[Docket No. 98-SW-74-AD]

Airworthiness Directives; Eurocopter Deutschland GmbH Model EC 135 Helicopters

ACTION: Notice of proposed rulemaking (NPRM).

**Figure 1**

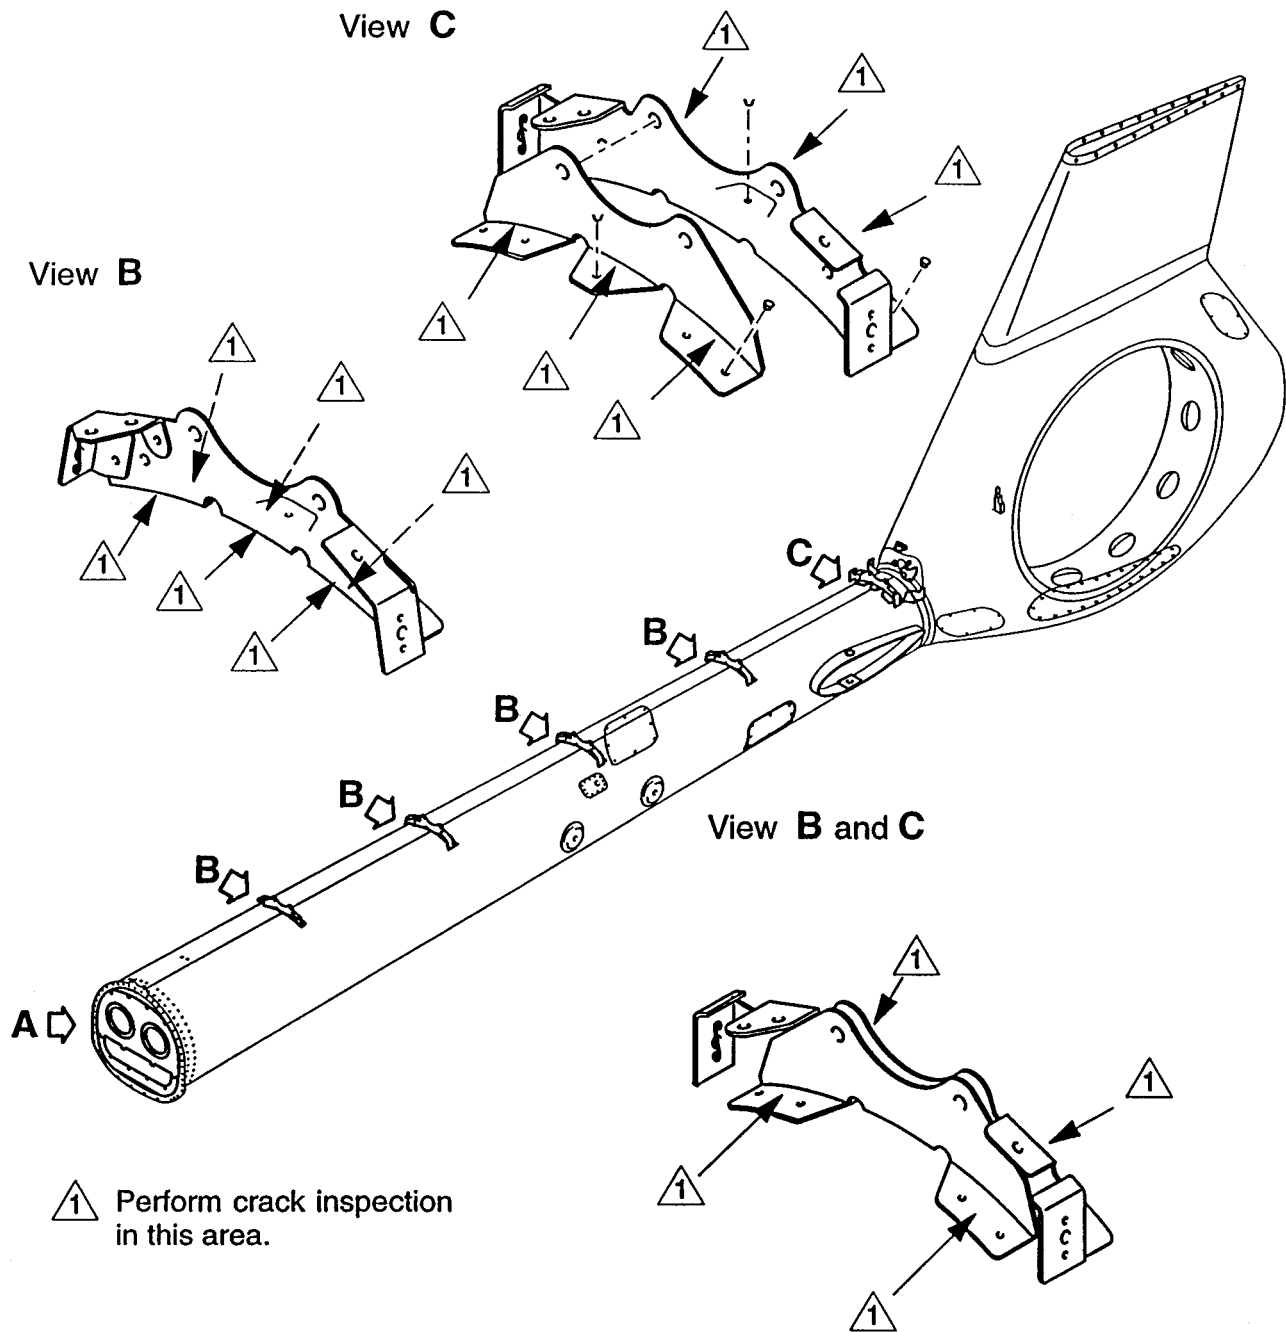
(1) Clean each tail rotor drive shaft bearing support. Using a 6-power or higher magnifying glass and a bright light, visually inspect the attach lugs of the bearing supports B and C (shown in Figure 1) for cracks, particularly in the area extending from the bend radius to the attaching screws and rivets connecting the bearing supports to the tail boom. Before further flight, replace each cracked bearing support with an airworthy bearing support.
